FAQ Title Non-Power Operations ClarificationsPlant: Callaway Energy CenterDate: May 20, 2016Contact: Mike FletcherPhone: (314) 974-8931Email: Mfletcher@ameren.comDistribution: *(NEI Internal Use)* 805 TF FPWG RATF RIRWG BWROG PWROG**Purpose of FAQ:**

FAQ Title Non-Power Operations Clarifications

See revisions to NEI 04-02 Section 4.3.3 and Appendix F below.

Figure F-1 Review POSs, KSFs, Components, Cables, and Identify Pinch Points

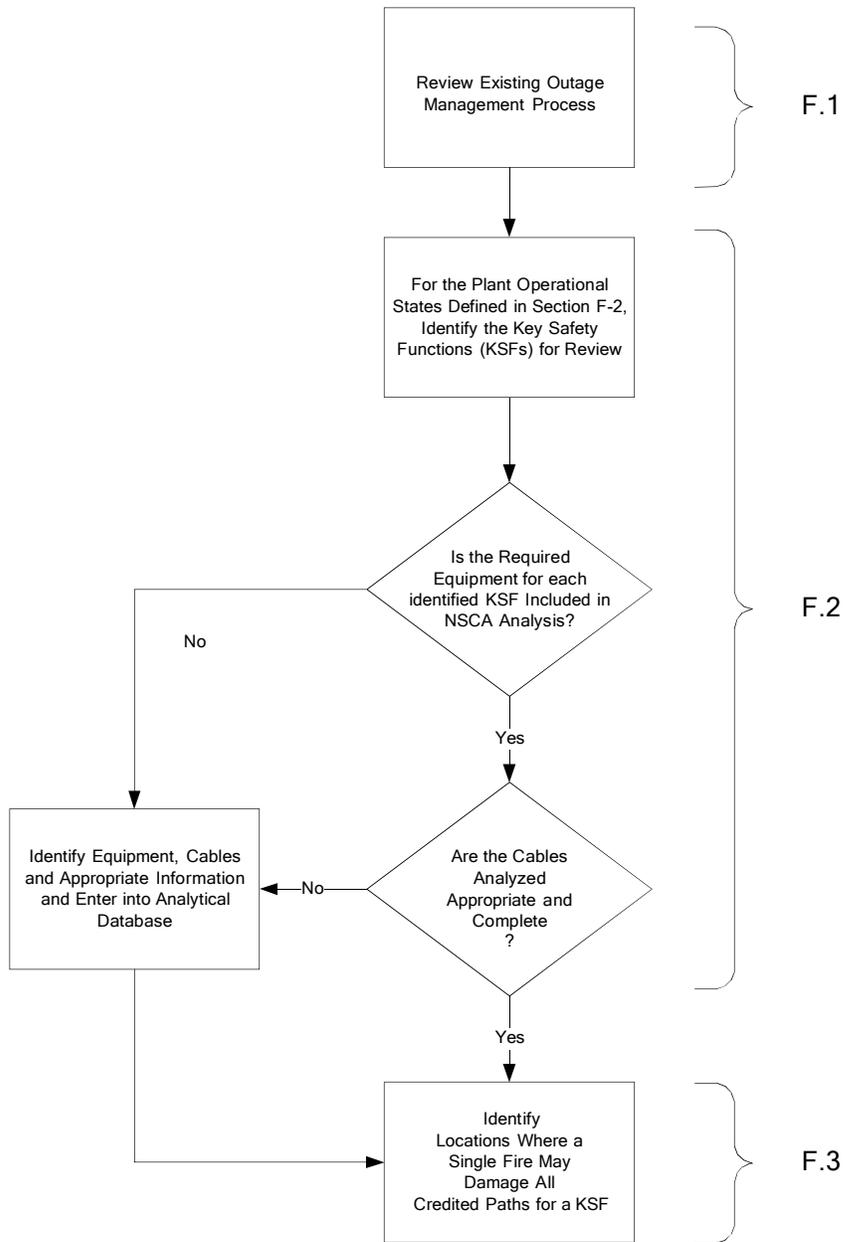
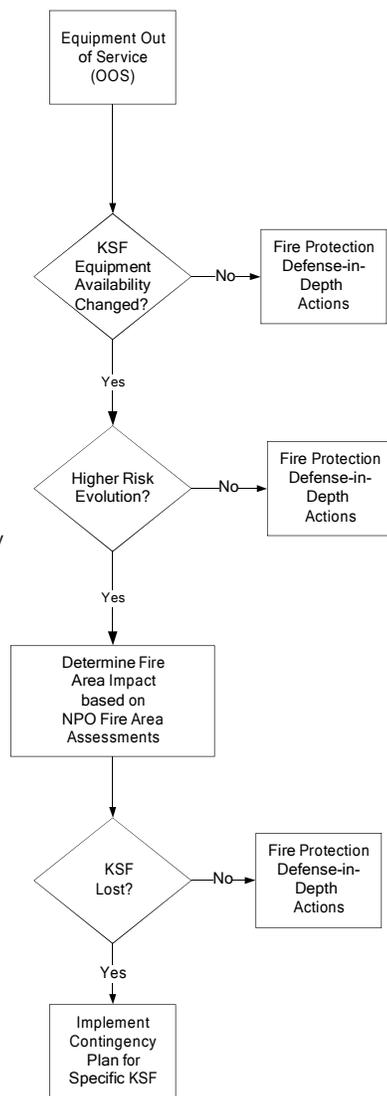
These steps are described in sections F.1 through F.4 below and the process is depicted on Figures F-1 and F-2. Implementation of the process should be documented in Table F-1.
